SB-1 EBMUD staff is not recommending selection of the Tice Pumping Plant alternative site. However, approval of WTTIP projects and project locations is at the discretion of the EBMUD Board of Directors. See **Response AH-2** regarding potential damage to protected trees.

This letter is written in response to EBMUD's request for comment on Draft Environmental Impact Report (hereafter referred to as DEIR).

The following comments are in response to the Draft Environmental Impact Report SCH # 2005092019 of June 2006 (EIR) that was written to assess the potential impacts of the Water Treatment and Transmission Improvements Program (WTTIP) proposed by East Bay Municipal Utility District (EBMUD). These comments are offered in three sections as follows; Section One: General comments concerning the EIR; Section Two: Comments specific to the New Leland Pressure Zone Reservoir Site Selection; Section Three Comments specific to the access routes identified for the "Preferred Site" for the New Leland Pressure Zone Reservoir Site

1-26-79 FM. PG. 26
 ASSESSOR'S MAP
 BOOK 241 PAGE 26
 CONTRA COSTA COUNTY, CALIF.

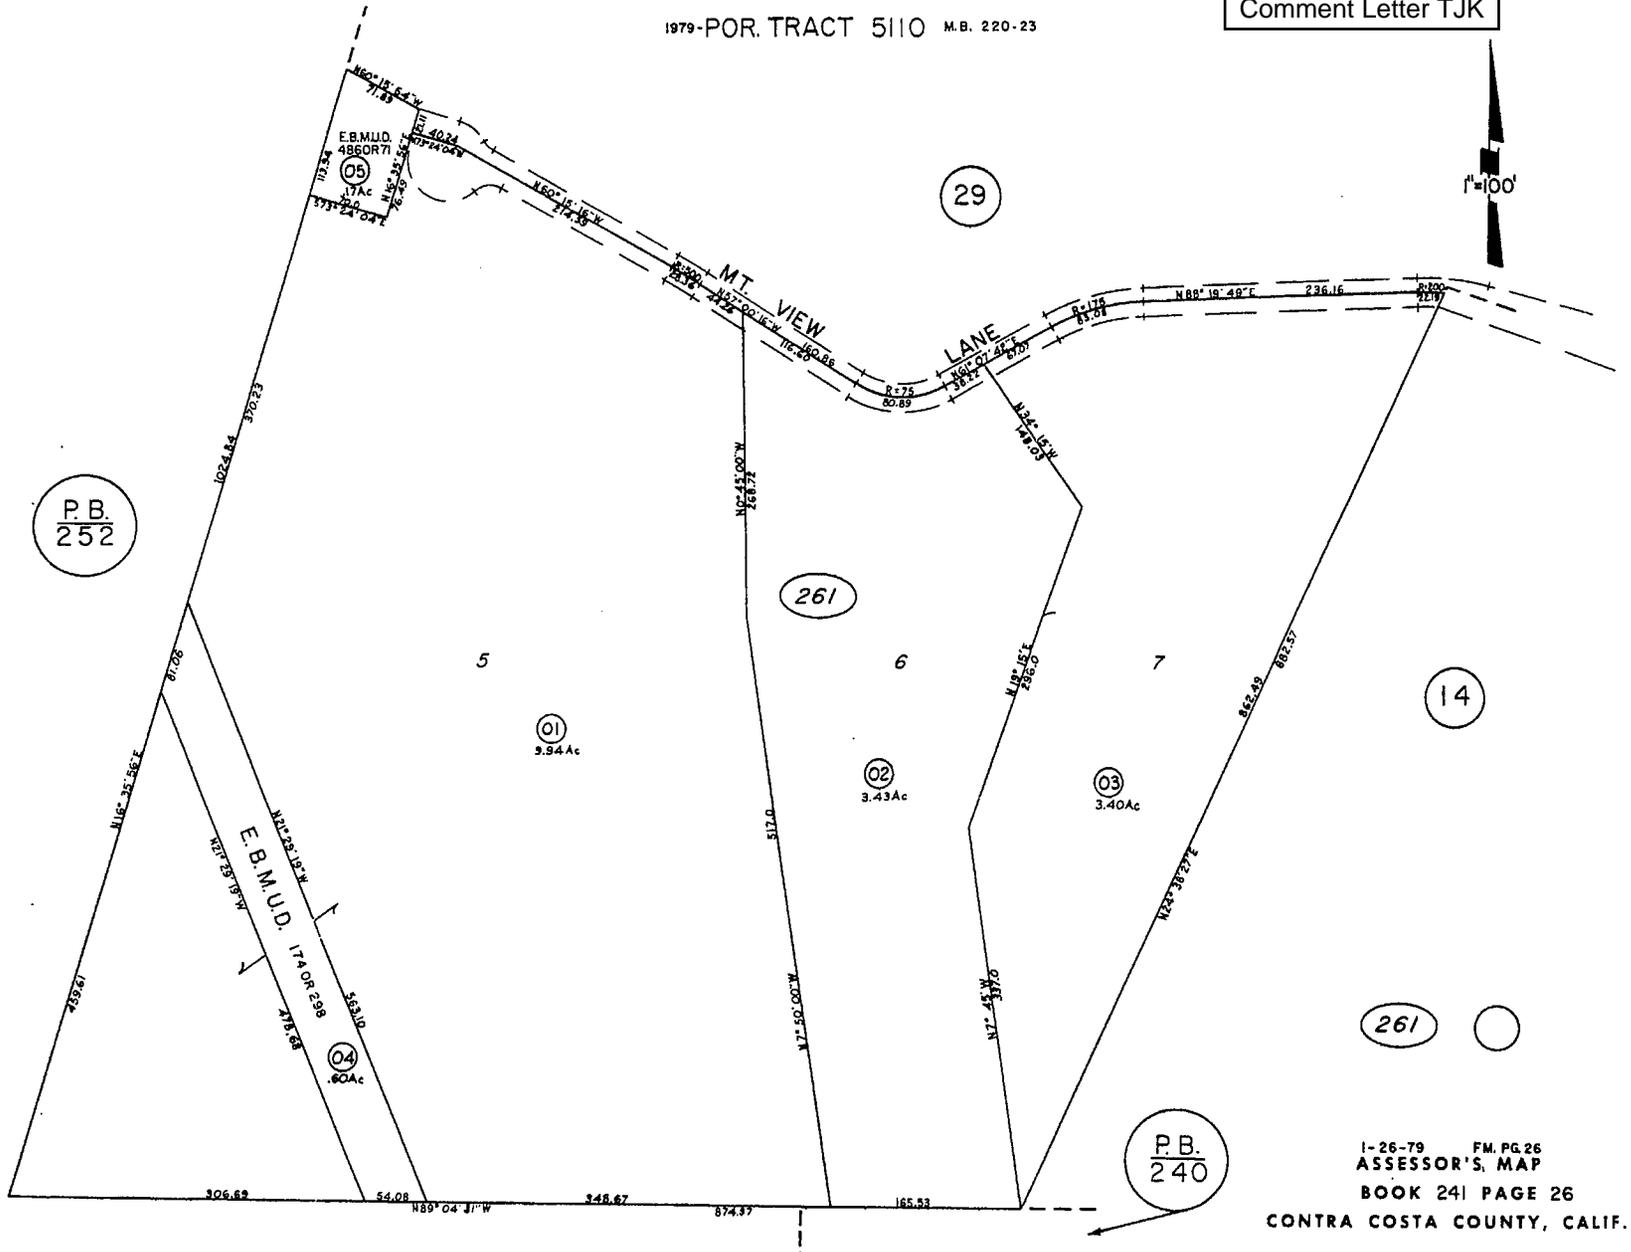
We are specifically concerned with the planned Moraga Pipeline portion that will cross a portion of our property as indicated on the enclosed map. Since this section will directly affect us as well as our property and views, we ask the following considerations:

1. To access the proposed project on our property EBMUD will have to cut through a portion of the existing fencing for ingress and egress at two locations. We also noticed in our recent review of the Moraga pipeline project that there are several locations along the fence that have either been broken down or worn out over the years. We request that EBMUD repair and replace the fence as soon as work on our property is completed and that the fence repair include those other areas near to the project so that no additional work and inconvenience will need to be done after the pipeline project is complete on our property.

2. There are two large concrete valve boxes on our property that are currently well hidden by existing trees, brush, and vegetation. We believe that almost all of that coverage will be removed for the Moraga pipeline. Because that coverage has taken years to mature and to hide those boxes, we request that EBMUD mitigate the unsightly exposure by planting new vegetation strategically so that the boxes will again be hidden by vegetation and that the vegetation include fast growing native species.

3. We noticed that the existing oak trees along the easement on our property are likely to be removed in order to install the additional pipe. We request that EBMUD make every effort to save these trees rather than remove them. If those trees cannot be saved, we

- request that replacement trees be planted according to the EBMUD EIR suggestion of three new trees to every one tree removed in locations as near as possible to the places where the trees were removed. We understand that native oak trees take a long time to grow so planting a small new tree is not really an adequate replacement for a tree that is nearing 50 years old. TJK-4

5. We request that any tree scheduled to be removed from our property or on the EBMUD easement be physically marked well in advance of its planned removal and that we be notified when a tree is marked so we can verify that each tree is within the EBMUD easement and subject to the EIR. TJK-6

- TJK-1 Comment and enclosures noted.
- TJK-2 EBMUD plans to stay within its property when installing the Moraga Road Pipeline. EBMUD will replace any fencing removed due to pipeline construction to pre-construction (or better) conditions, and EBMUD will repair the fence in the general area to the extent it is an EBMUD fence.
- TJK-3 EBMUD will provide screening of these valve boxes if they are exposed during and as a result of the pipeline construction work. Replacement of trees along the Moraga Road Pipeline project is addressed by Measures 3.6-1a through 3.6-1d (DEIR p. 3.6-33).
- TJK-4 Impact 3.6-1 in Section 3.6, Biological Resources, addresses impacts to oak trees for the Moraga Road Pipeline project (Table 3.6-4, DEIR pp. 3.6-28 and 3.6-33).

Throughout the CEQA review for the WTTIP project EBMUD has made efforts to avoid tree removal through site redesign and consideration of alternatives. Measure 3.6-1e specifically relates to the Moraga Pipeline, requiring that its alignment be refined during design, to the extent feasible and within hydraulic constraints, to avoid removal of protected trees. If the trees on the commenters' property are considered protected (i.e., oak trees), EBMUD will make every effort to avoid removing them. If it is necessary to remove them, EBMUD will replace them at the ratios specified in the DEIR. Site conditions warranting, and if necessary, replacement trees shall be placed as close as possible to where existing trees were located, though not over either the existing or new pipelines. See **Response TJK-7**. See **Response LAF-10** for clarification and specification of mitigation regarding replacement trees.

- TJK-7 Pursuant to Measure 3.3-2b, the District will require that contractors restore disturbed areas along pipeline alignments to pre-project conditions. This will include replanting shrubs and trees. It is not possible to safely plant trees directly over a pipeline, but a setback will be established and trees will be planted outside the setback. The landscaping and tree planting will be the last task of the construction phase taking place in the Lafayette Recreation Area Open Space. The 30 days requested will likely not be feasible.

- TJK-10 EBMUD will provide temporary construction fencing and signage at breeched fencing locations in order to reduce the risk of non- authorized personnel trespassing into EBMUD's property and subsequently the commenters' property.

- TJK-11 Throughout the CEQA review for the WTTIP project, EBMUD has tried to avoid tree removal wherever possible through site redesign and consideration of alternatives. Measures 3.6-1a through 3.6-1e, which will be adopted as conditions of project approval, provide measures and methods to minimize impacts on trees. When tree replacement is necessary, and site conditions warrant, replacement trees shall be placed as close as possible to the original locations.
